UTAC

R134

Drop test clarification

11/2024

The four drop orientations are illustrated in Figure 1.

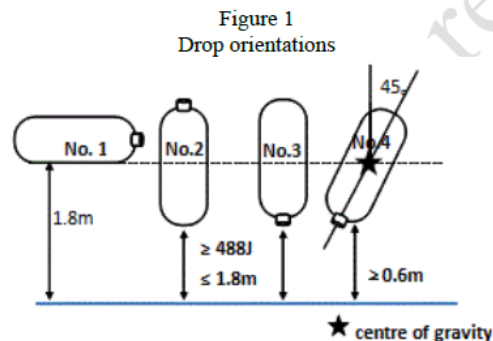
→ One or more additional container(s) dropped in each of the 4 orientations

→ Updated in serie 2

→ Our understanding : one container(s) dropped in one of the orientations

But in the sentence, it is not specified who choose the orientation ? Usually in regulations, it is specified if it is up to the Technical Service / authority, or the manufacturer, or an agreement between the two to take the decision.

The test article shall be dropped in any one of the following four orientations *The orientation chosen for the test shall be determined by the Technical Service, in consultation with the manufacturer.*
